**Technical memorandum for an application for subdivision consent
under the Resource Management Act 1991 in respect of 25 Punawaitai
Road, Pourerere Beach**

From: Iain Lachlan Grant, Director, Landvision Limited

Application number: RM220003

Figure 1. NZLRI LUC classification beyond the property boundary.

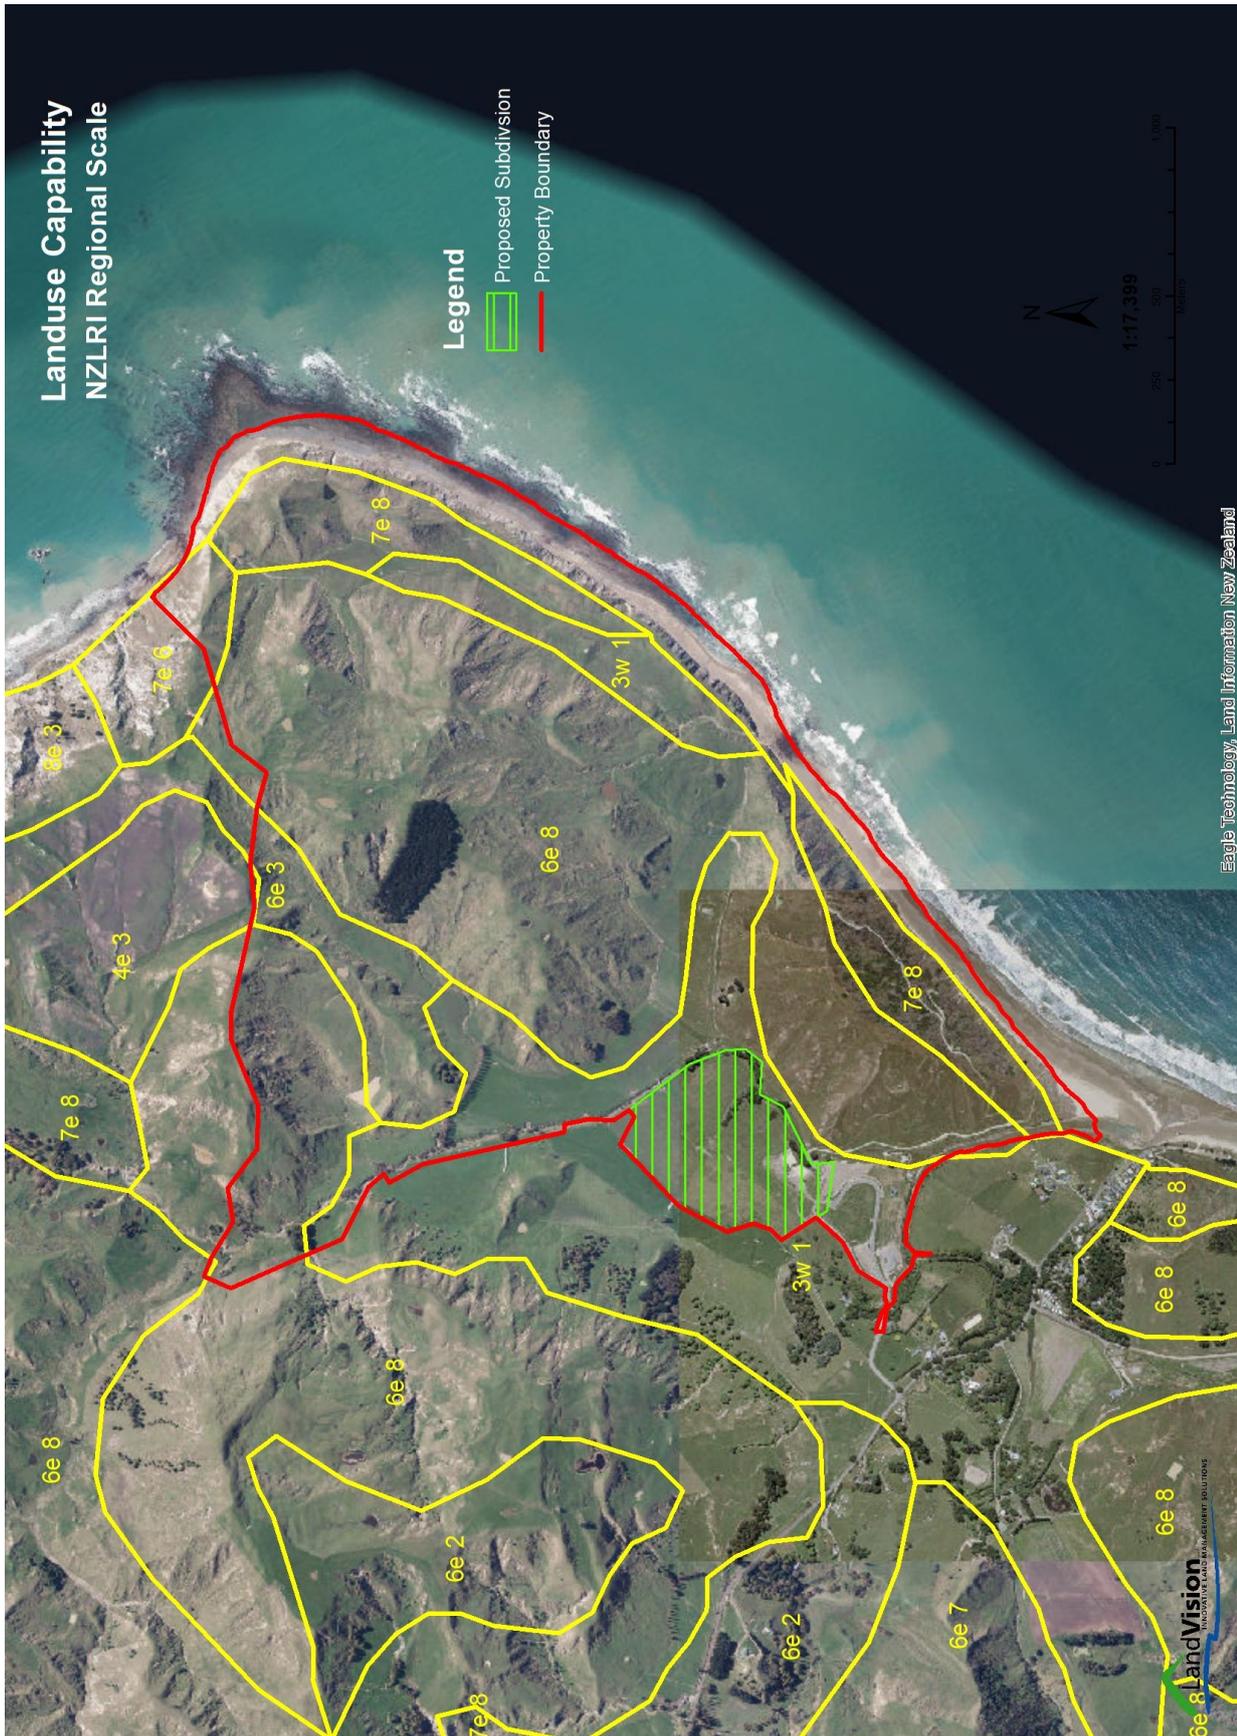
- 9.5. At the paddock scale mapping (i.e., 1:7,000 scale) there is one observation point every 0.6 ha.
- 9.6. Figure 1 in Appendix 1 to this memorandum shows the LUC distribution of the proposed subdivision area, the whole property, and the surrounding land. This shows that the New Zealand Land Resource Inventory (**NZLRI**) has mapped the proposed subdivision area as 3w1 land, which is relatively flat land formed from alluvium. I consider that the entirety of the proposed subdivision area appears to fall into the 3w1 LUC unit.
